CHANGES TO CONSENTED SCHEME

APPLICATION FOR SECTION 73 AMENDMENT

POSTAL MUSEUM, CALTHORPE HOUSE
MOUNT PLEASANT, LONDON
EAST ELEVATION (EXTENSION)
CONSENTED SCHEME &
PROPOSED AMENDMENTS
Do not scale
Original printed at A1

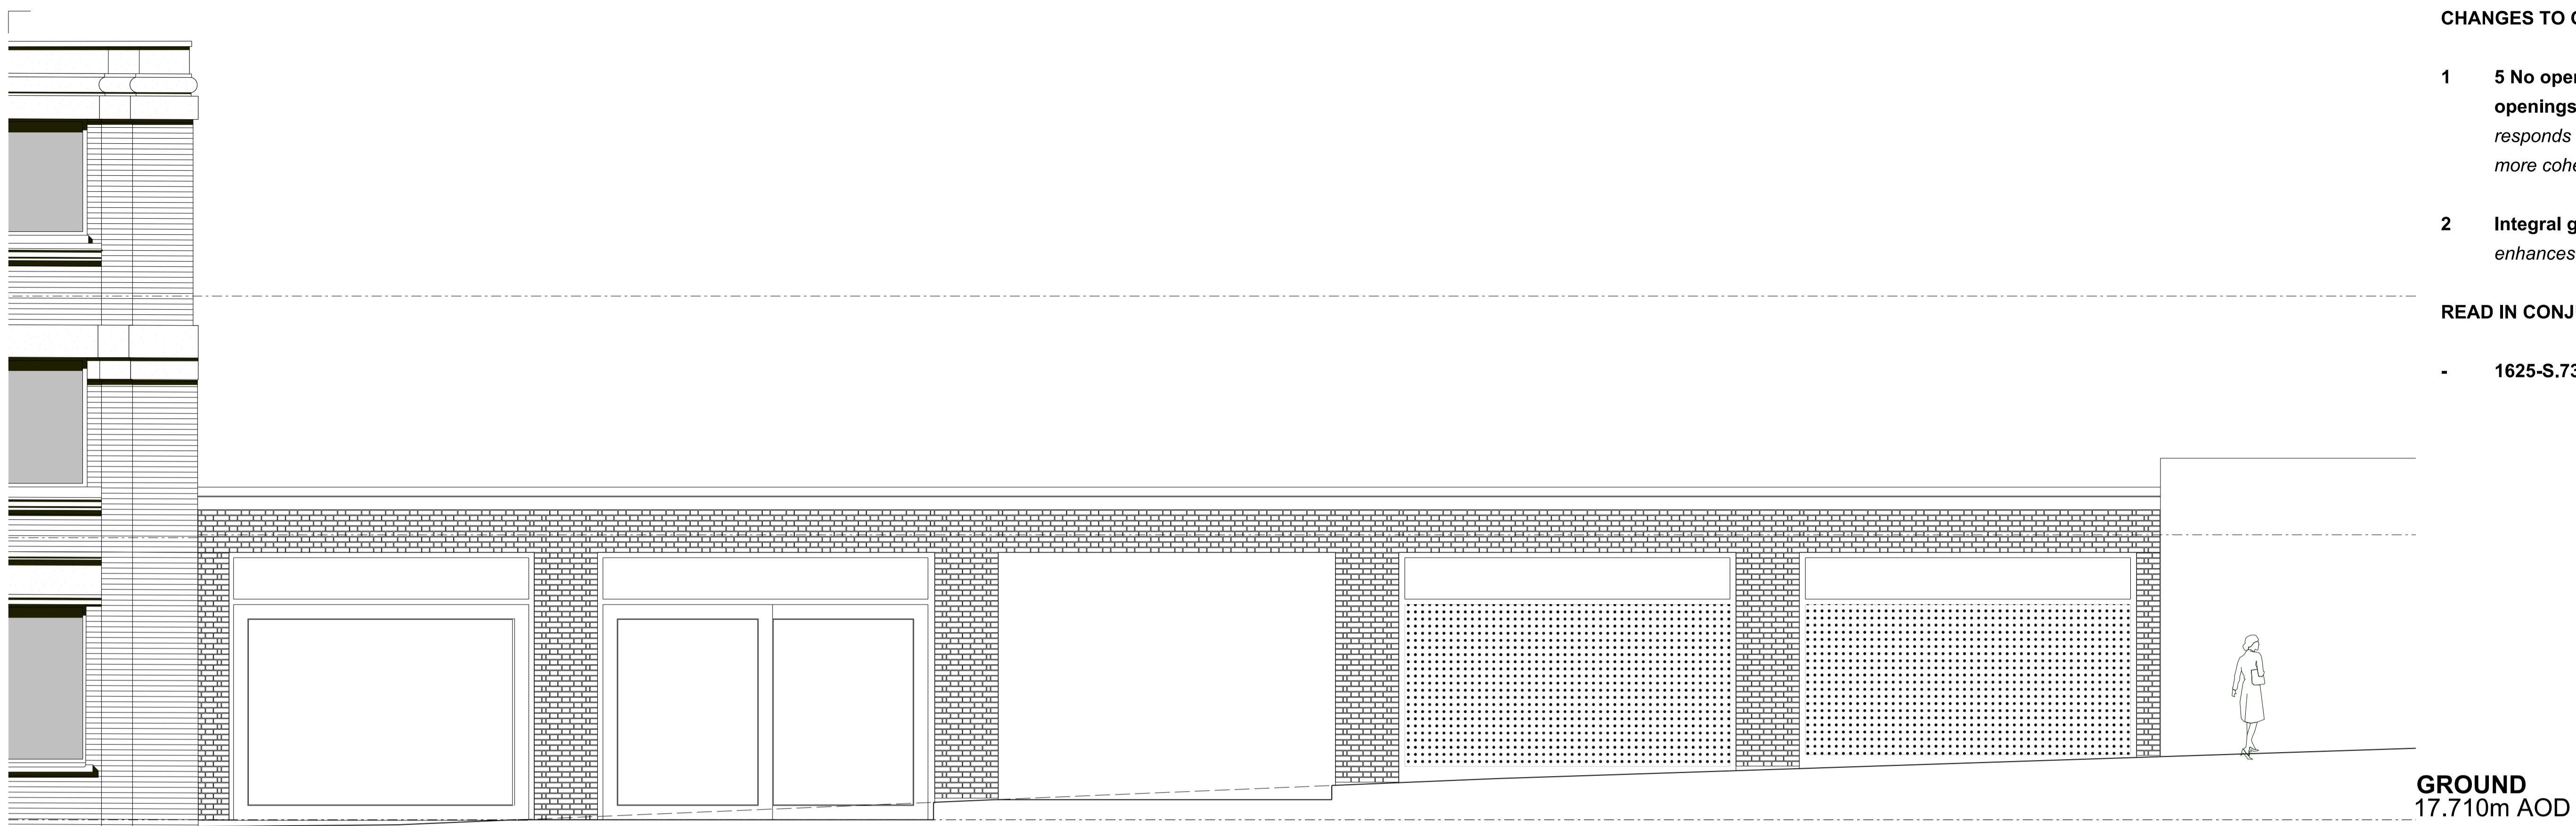
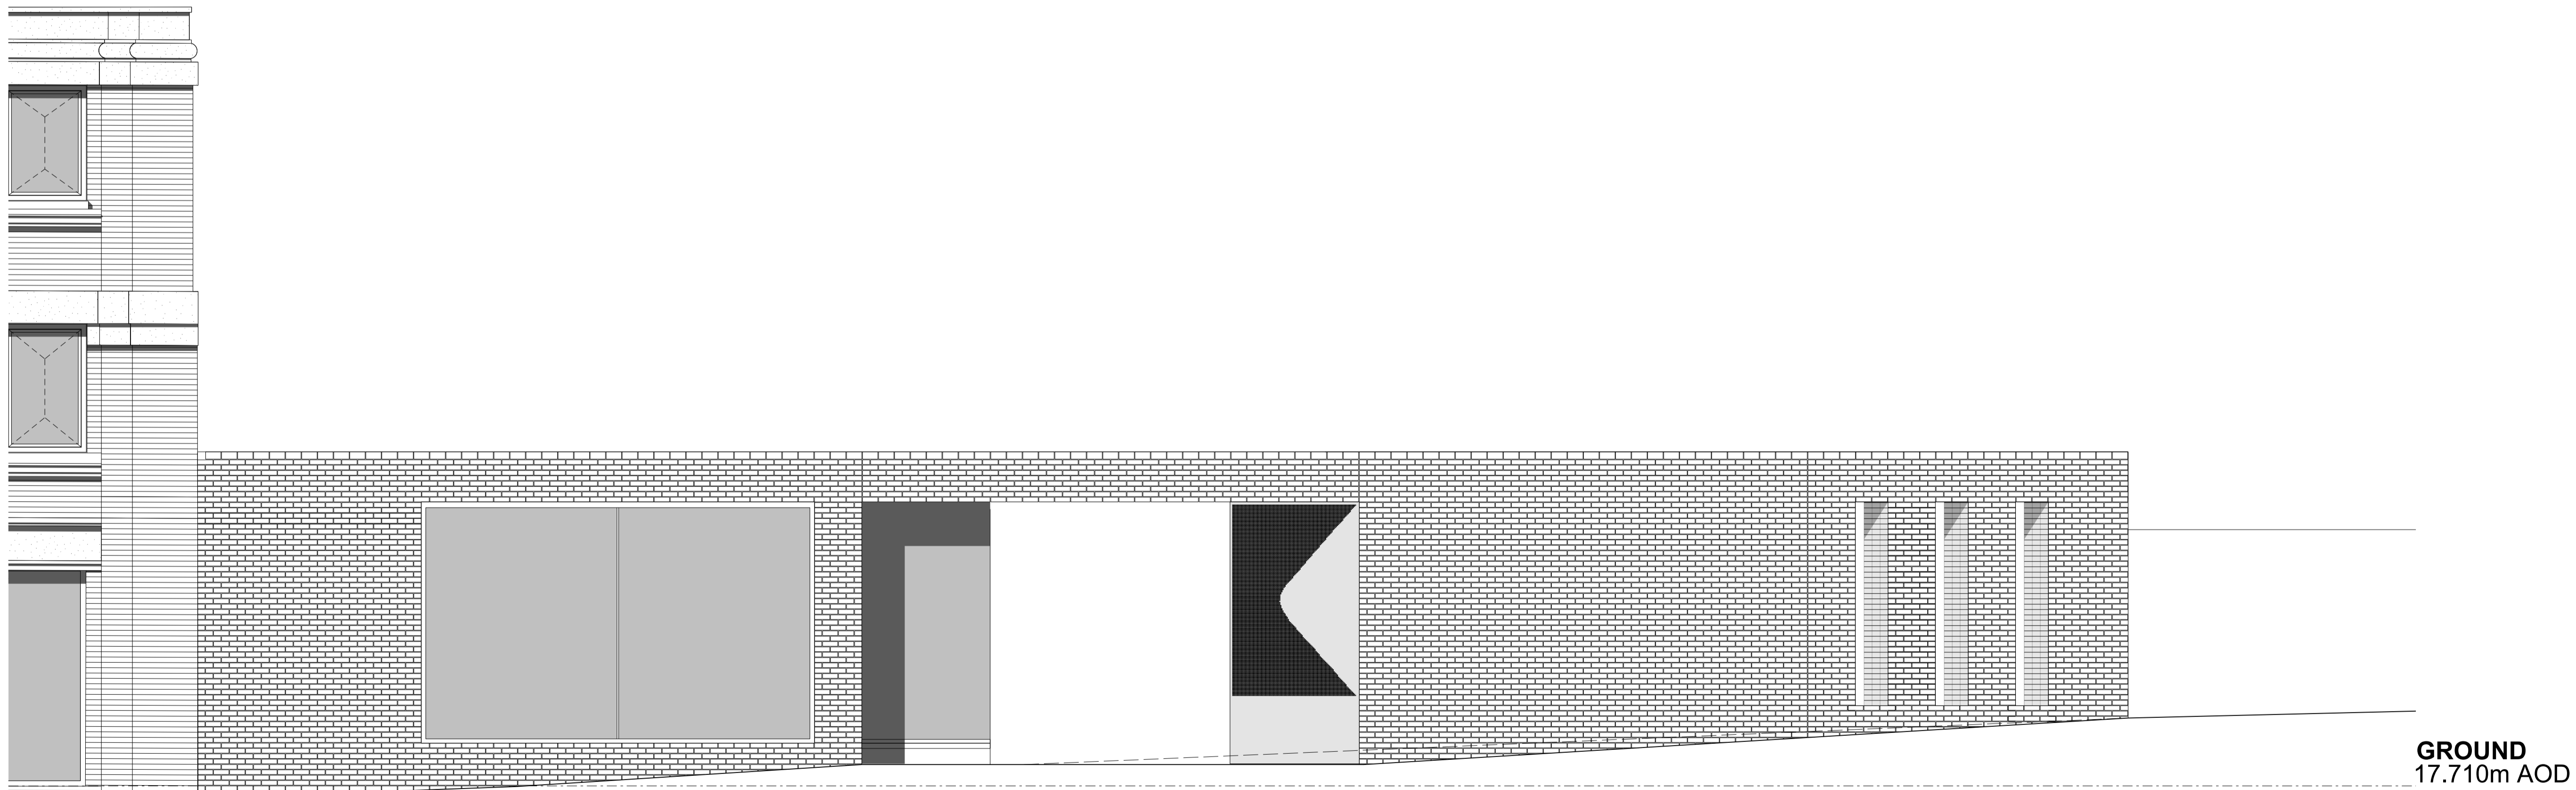
- 1** 5 No openings reduced to 2 No larger openings, with 3 No slots
responds to the space changes, and provides a more coherent design.
- 2** Integral gate shown
enhances the security, and improves access.
